Why Gillman Forest

Gillman Forest Development

Executive Summary

Figure 3. Depot Industrial Estate. Source: Urban Redevelopment Authority.²⁷

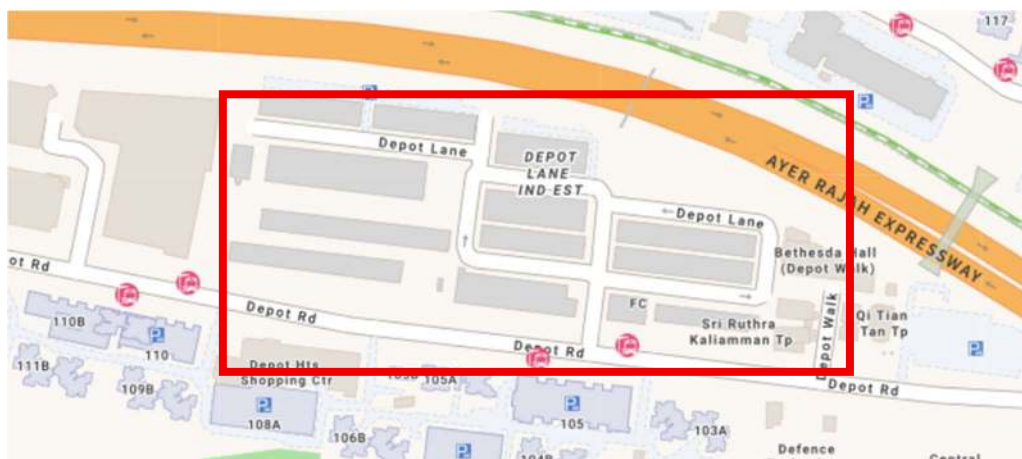
According to secondary reporting on URA's Draft Master Plan 2025, Depot Lane Industrial Estate (situated next to Gillman Barracks) is planned to be returned to the state by the end of 2025, with the approximately 7.3-hectare site earmarked for residential redevelopment. We note that we have not been able to independently verify this specific figure or designation through URA's own published materials, and would ask URA to confirm the site's status, size, and redevelopment timeline directly.

If it is accurate that Depot Lane and Gillman Barracks are being grouped together under a single planning designation, it would be reasonable to ask whether the two sites' housing contributions are being assessed jointly, and whether Depot Lane's yield has already reduced, or could further reduce, the pressure to clear Gillman Forest. Given that we could not confirm this cluster designation through URA's own published Master Plan materials, we would ask URA to clarify whether such a joint plan exists, and if so, how the cluster's overall housing target is split between the two sites.

We ask HDB and URA to confirm: (i) the current status and land area of the Depot Lane Industrial Estate site; (ii) whether it is indeed planned jointly with Gillman Barracks under a combined cluster designation; and (iii) if so, what housing yield Depot Lane alone is projected to contribute, and whether this has been factored into the case for clearing Gillman Forest.

Figure 4. Central Manpower Base (CMPB). Source: Urban Redevelopment Authority.²⁷

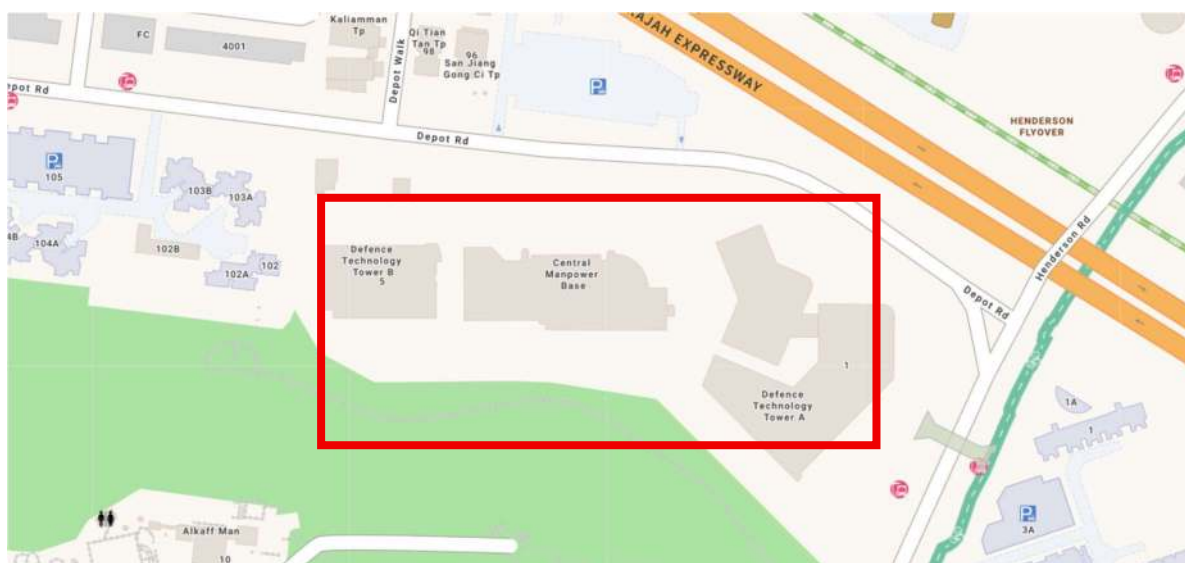
The former CMPB compound sits on approximately 5.63 hectares along Depot Road, within Bukit Merah town and close to Redhill MRT and the Central Expressway. Unlike Gillman Forest, this is not an intact ecosystem — it is a cleared, built-up government compound that has already served a non-residential institutional purpose for over three decades. Since CMPB's relocation to Bukit Gombak was completed in October 2025, this site now sits vacant, with no operational use.

Under Master Plan 2025, the site remains zoned "Civic & Community Institution" with no Gross Plot Ratio assigned, confirming that it has not yet been committed to any specific future use. This stands in contrast to Gillman Forest, where clearance is being actively pursued despite the forest's irreplaceable ecological value. HDB/URA should exhaust redevelopment options on land that requires no ecological loss before turning to forested sites.

We ask HDB and URA to clarify whether the former CMPB site at 3 Depot Road has been considered for public housing redevelopment, and if not, why a vacant, already-cleared government site within Bukit Merah town has not yet been prioritised ahead of proposals to clear Gillman Forest.

Figure 6. Left: Original planning concept by HDB, adapted from The Straits Times (Ng, 2026)³³. Right: Alternative planning concept proposed by the author.

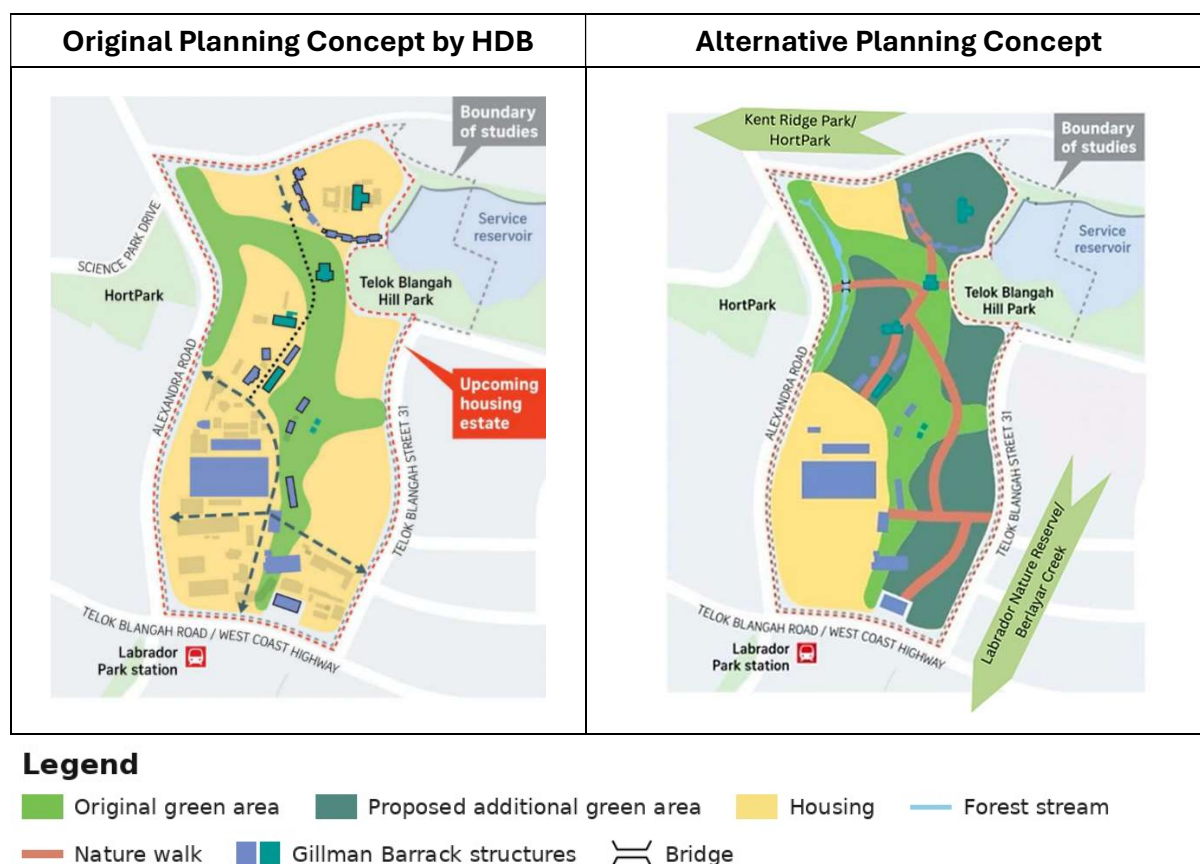
If development is demonstrated to be necessary despite the above measures, the next priority should be to reconfigure the site to retain one large, contiguous block of forest rather than a narrow strip vulnerable to edge effects. The aim is a better-connected, higher-quality forest that continues to function ecologically, while providing meaningful benefits to both existing and future residents.

Ecological advantages:

- retains a larger contiguous forest habitat, reducing edge effects and fragmentation;
- strengthens ecological connectivity all around Southern Ridges;
- improves thermal comfort through greater tree canopy cover; and
- retains majority of the forest stream* (Appendix B, Figure 4-21);

This alternative configuration retains two residential areas consistent with HDB's original plan: a larger southern area comprising the Academy of Singapore Teachers site and non-conserved portions of Gillman Barracks, and a smaller northern area beside the retained string of Gillman Barracks structures. Remaining parcels are converted to additional green areas, concentrating new housing within land already committed to development rather than displacing additional forest. Current residents in existing estates will benefit from the retained greenery, rather than limiting the advantageous health and physical effects of the forests to residents of the new estate.

The wider green corridors created by this configuration also strengthen connectivity in two directions: southward to Labrador Nature Reserve and Berlayer Creek, and westward to HortPark and Kent Ridge Park — reinforcing the site's role within the broader Southern Ridges network.³⁴

Figure 5-2: Slope Map and Zoning for the EIA Study Area

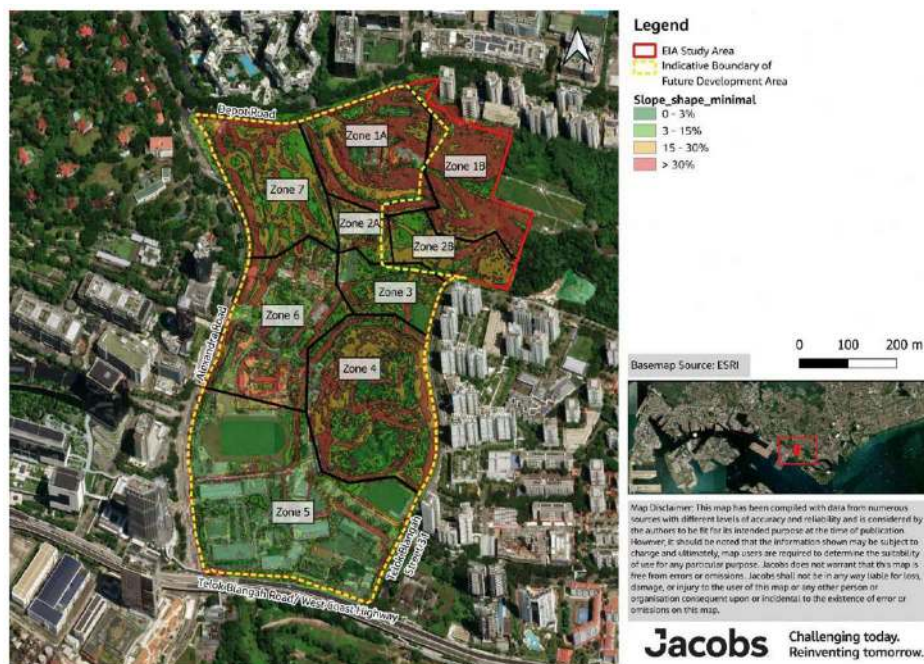
The EIA's slope map (Appendix A, Figure 5-2) identifies Zones 1A, 1B, 2B and 4 as predominantly >30% slope ("very steep" under the USDA classification). These zones closely overlap with the native-dominated secondary forest which the EIA's habitat mapping (Appendix B, Figure 4-21) has marked as Proposed Retained Area. The terrain too steep to develop historically is also the terrain of highest ecological value today. Developing these zones would require extensive cut-and-fill earthworks and slope-retaining structures, increasing cost, erosion risk, and sediment yield into drainage that ultimately reaches Berlayer Creek — compounding ecological loss with construction risk and higher cost. Concentrating development in the flatter, already-disturbed zones (e.g. Zone 5) is therefore preferable on ecological, engineering, and cost grounds alike.

Given the site's hilly terrain identified in the EIA's slope mapping (Appendix A, Figure 5-2) and the replacement of permeable forest with buildings and roads, planning should demonstrate how stormwater will be managed to ensure the development does not increase surface runoff, erosion or flood risk to neighbouring properties, roads, or the forest stream and Berlayar Creek downstream.

Figure 4-21: Proposed Retained Area and Area of Habitat Creation

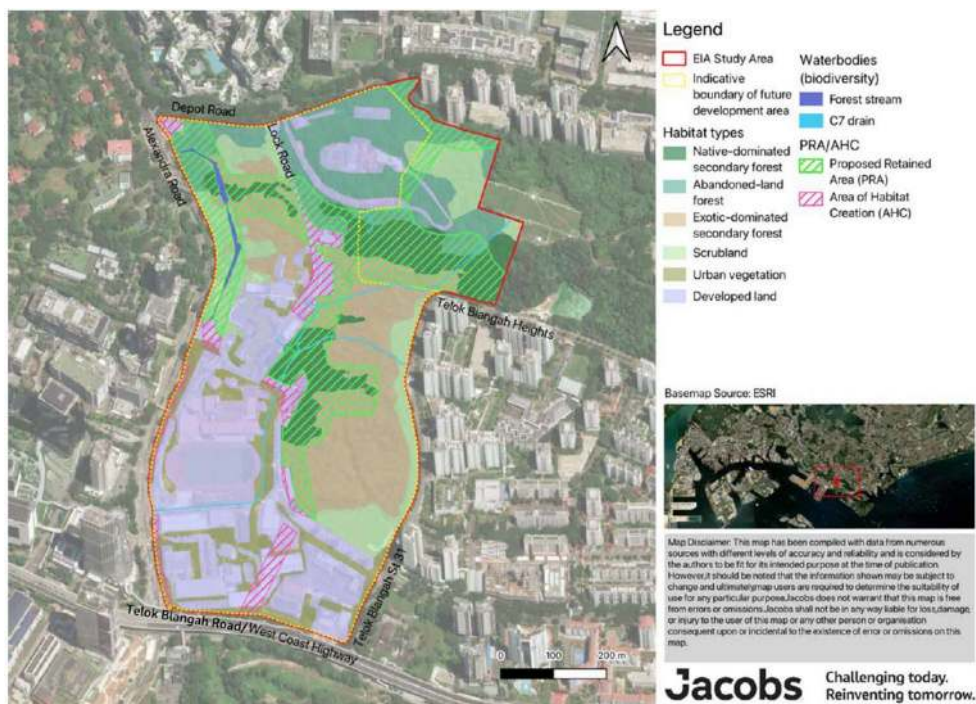
However, the Gillman EIA's own Proposed Retained Area achieves only a 30m minimum width in its narrowest sections, only expanding closer to 200m within denser existing forest.¹³ This means that, by the EIA's own stated standard, sections of the proposed corridor fall short of what is required to avoid double edge effects — precisely the scenario the Berlayar EIS's connectivity assumptions depend on remaining intact.

* Note: Based on the forest stream identified in Appendix B (Figure 4-21). The hydrological survey (Appendix C, Figure 6-3) was not considered, as the ecological value of the numerous surveyed streams and drains was not stated.
